IN THE DRAWINGS:

REMARKS:

FIG. 9

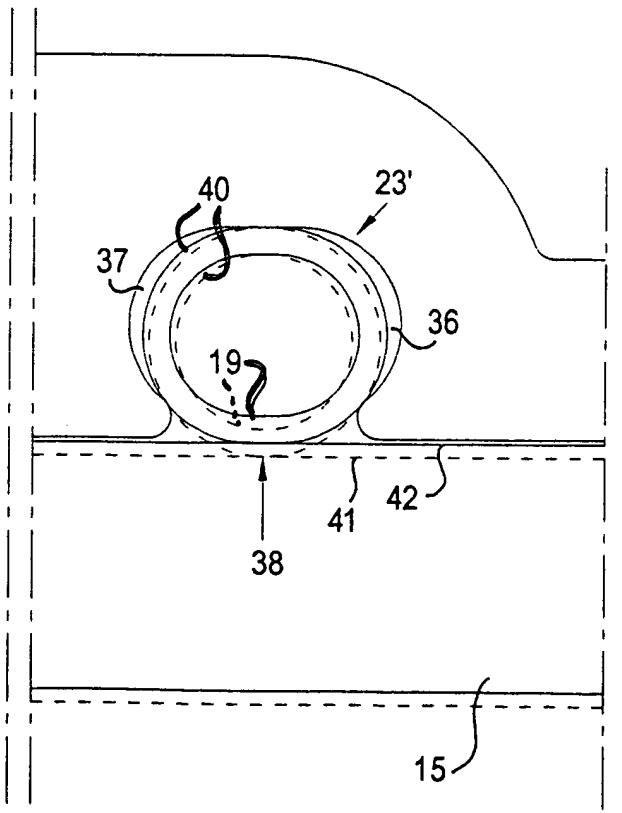
- 1) The directional line for numeral 40 has been moved to point to the solid line shape to correctly identify the "deformed state 40 of guide member 19" in Fig. 9; and
- 2) The directional line for numeral 19 has been changed to a dotted line and has also been moved to point to the dotted line shape to correctly identify "guide member 19" in Fig. 9.

Drawing Fig. 9 has currently been amended to correctly show "deformed state 40" as solid lined and the numeral 19 is now shown to be directed to the dotted line shape. Two (2) sheets, one entitled: "Annotated Marked-Up Drawings" and one entitled: "Replacement Sheet" are included herewith. No new matter has been included. The modifications only corrects the character lines for accuracy as indicated.
